Turbidity Monitoring
on the Lower Kenai River, 2008-2010

DRAFT

Final Report Date: June 29, 2012

Reviewer   Page   Comment

Figure 9: Cumulative Frequency Curves for RM 11.5 AM Data and All RM 23 Data.

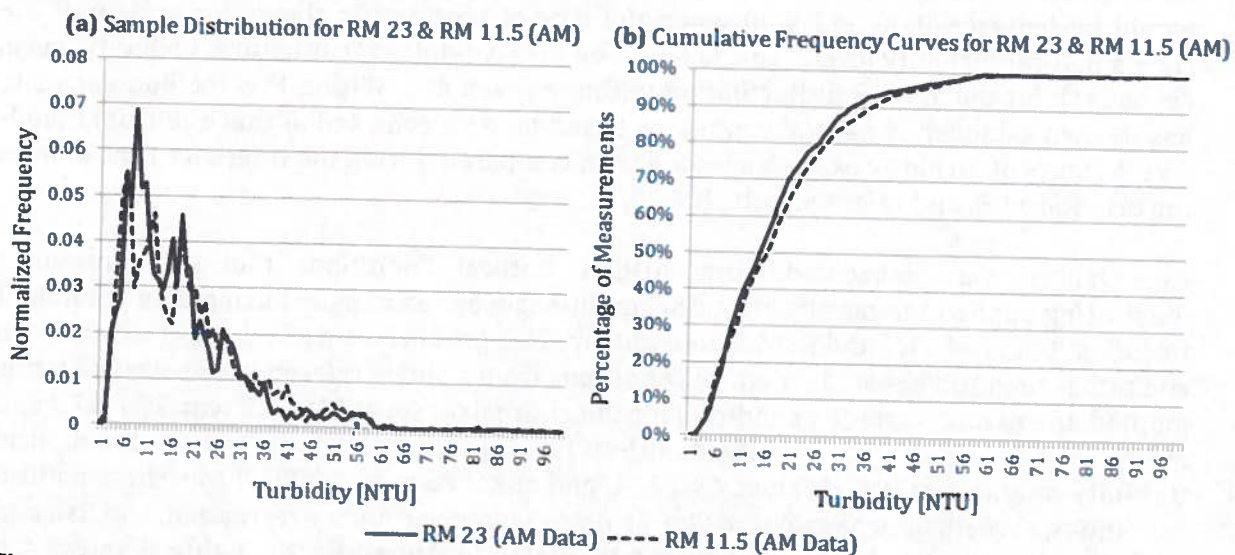
MAM   --   **1.1.1.** You mention that a source of turbidity is glacial silt from the headwaters. Is there a diurnal signal to this contribution? I didn't see much in Fig. 9 but the vertical scale did not allow me to see the details of the little blips. If the meltwater contribution is lowest during early morning hours, one would expect the low turbidity values you measured from midnight to 5 a.m. to be at least partly due to the lower glacial silt contribution. This wouldn't change your ratios between RM 23 and RM11.5, but it gives more insight into the mechanisms of turbidity production.

Response/Action: *Based on the data analysis done in this study there was no apparent diurnal signal. An understanding of diurnal signals would be an interesting study in the future but it was not a necessary component in the calculation of exceedances.*
